ADDENDUM No. 1

COUNTY OF SAN DIEGO – REQUEST FOR PROPOSAL (RFP) 9065 SHERIFF'S DEPARTMENT BELL 407 GXi HELICOPTER

UC6000 TO LOJACK PTC-3-FP (RS-232)

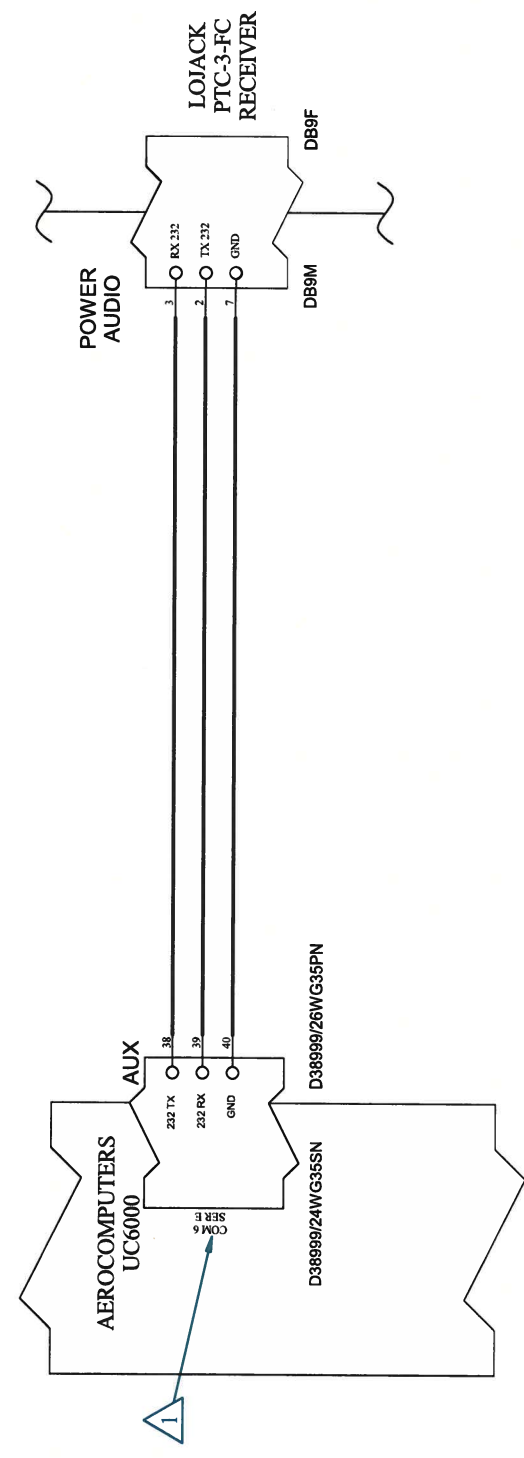
Q. Reference paragraph 4.44. The Lo-Jack Tracking System model PTC-3, with interface with UC-6000 computer system will need to be customer furnished (same as previous 407), Bell will install the "Provisions Only / Includes Antennas/Wiring/Mounts". Please confirm acceptance.

A. **Yes the Sheriff's Department will provide the PTC-3 low jack unit that will interface with the UC-6000 computer, we are requesting that "provisions only" to include the antennas/wiring/mounts. (Wiring diagrams attached).**

UC6000, UC5100 TO VISLINK (HDX 1100) RS-232

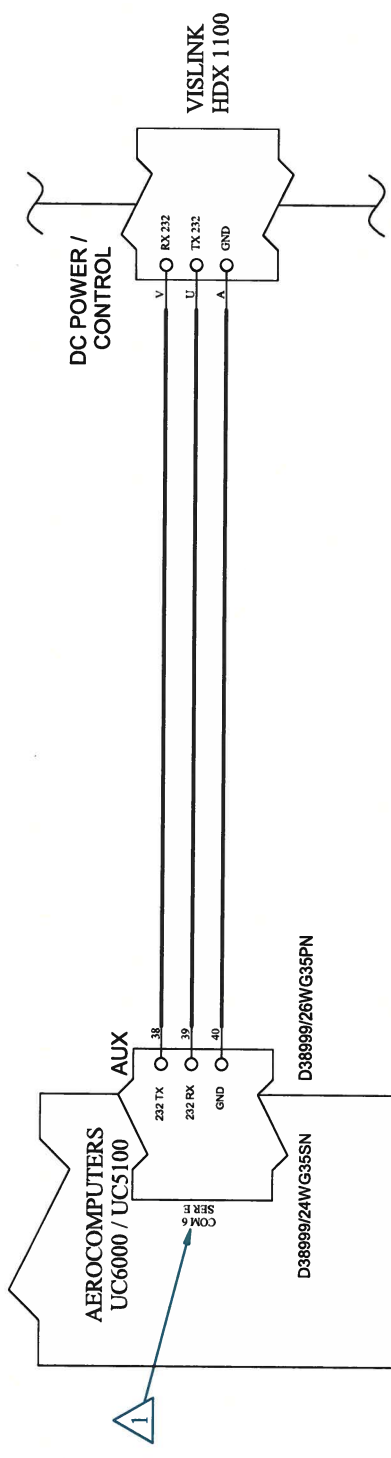
Q. Reference paragraph 4.45. The "Video Down Link System with Recorder: Vislink Transmitter HDX 1100, S-band HD Video downlink with fix antenna. P/N HDX-1100" does not include a remote control, controlled by map system (as per vendor). Please confirm acceptance.

A. **Yes we have been directed by the map vendor that a remote control is not needed. (Wiring diagrams attached).**
